YANMAR SERVICE NEWS					
Subject	Design Change of Indicator Cock		No.: 17-2-G-10-009-L-rev.1 Dec. 2017		
Engine Mod	6EY18, 6EY22, N21	Use	Marine Propulsion & Aux. Industrial		
Linginic Wiodi		Engine Nos.

Fig. Details of Indicator Cock

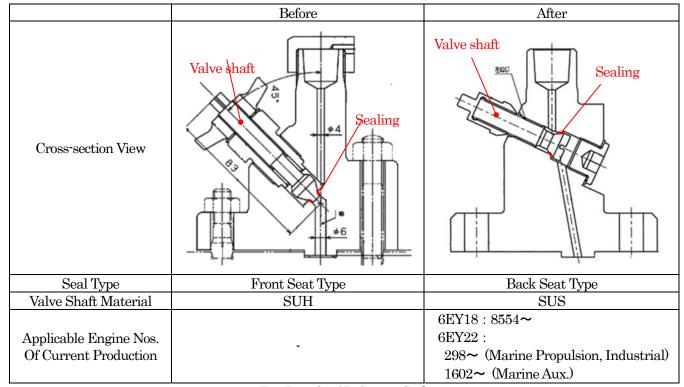
In several markets, the indicator cock blow-by, after use of short time, has been caused sporadically. The contributing factors considered are forgetting to fasten, catching foreign substance and premature corrosion due to faulty combustion. In this relation, to raise the sealing performance and corrosion-resistance, we have changed the indicator cock design as follows. Please refer to this design change when you need to refit the cock.

^{*}Insulator is necessary because surface temperature rises.

^{*}T handle for the indicator cock is not changed.
